State Significant Development Application 8008

Response to Submissions Report

Taronga Zoo, Sydney
African Savannah and Congo Forest Exhibits

14 November 2017 | 16527

Figure 5 – Overlay of Original and Early Paths (99L)

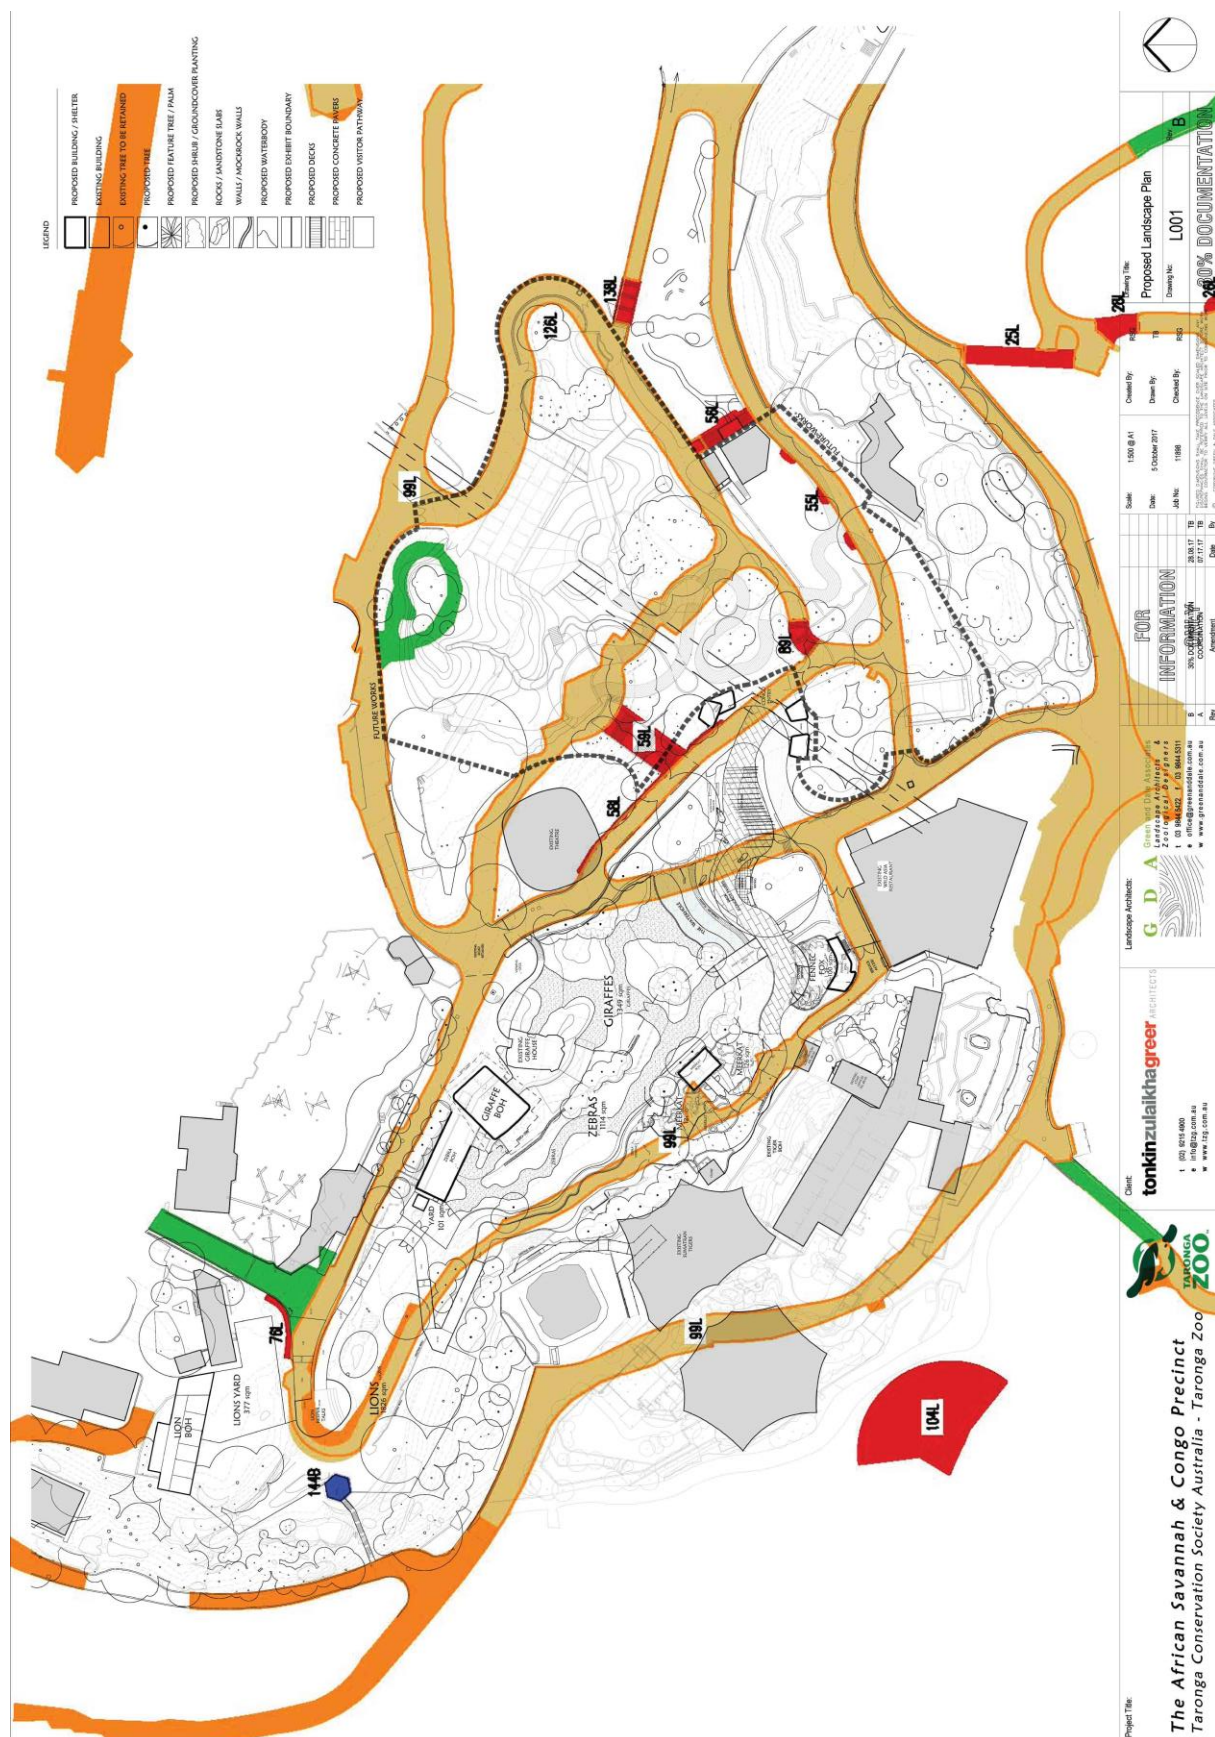
Provide a diagram which clearly shows the alignment of the Original and Early Paths (item 99L) overlaid on the projects architectural and/or landscape plans.	A diagram showing the overlay of the Original and Early Paths (item 99L) on the proposed development footprint (as amended) is included at Figure 5, Figure 6 and Appendix I .
Table 27 in the EIS appears to incorporate comments in the consideration of heritage impact that do not stem from the HIA. The table also does not include the HIA's comments regarding the impact on the zoo as a whole.	Table 27 in the EIS relating to the assessment of heritage impacts of identified items of significance incorporates content from the HIA (paragraphs and tables 7.2-7.2 and 7.5-7.7) and commentary provided by TCSA on the justification/ reasons for the identified impact including key project drivers such as animal management and life sciences measures. In response to DPE's comments Table 27 has been revised in Section 6.1.1 of this report (refer to Table 6).

Figure 11 – Giraffe and Zebra Exhibits comparison

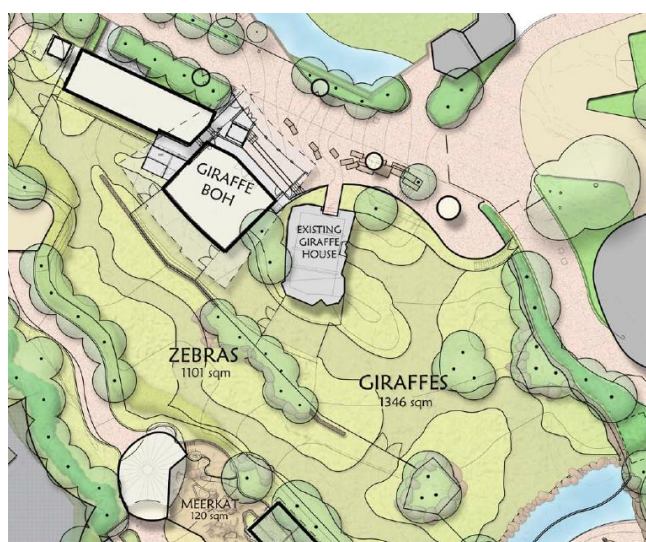
These changes have occurred in response to issues of scale, bulk, visual impact and heritage impact raised by DPE and other agencies.

The proposed design amendments have resulted in substantial modifications to the proposed Giraffe House and back of house area. Notably:

- The Giraffe House footprint has been reduced by approximately 34% (approximately 238m²) (upper and lower ground areas combined). This reduction includes the consolidation of two to one indoor yard;
- The Giraffe House roof area has been reduced by approximately 49% (325m²) and lowered in height by approximately two metres to RL 62.755 AHD. The roof remains vaulted, consisting of multiple segments to provide good cross ventilation and reduce the bulk of the building; and
- The Giraffe House has been relocated further west to provide separation distance between the existing heritage 1924 Giraffe House.
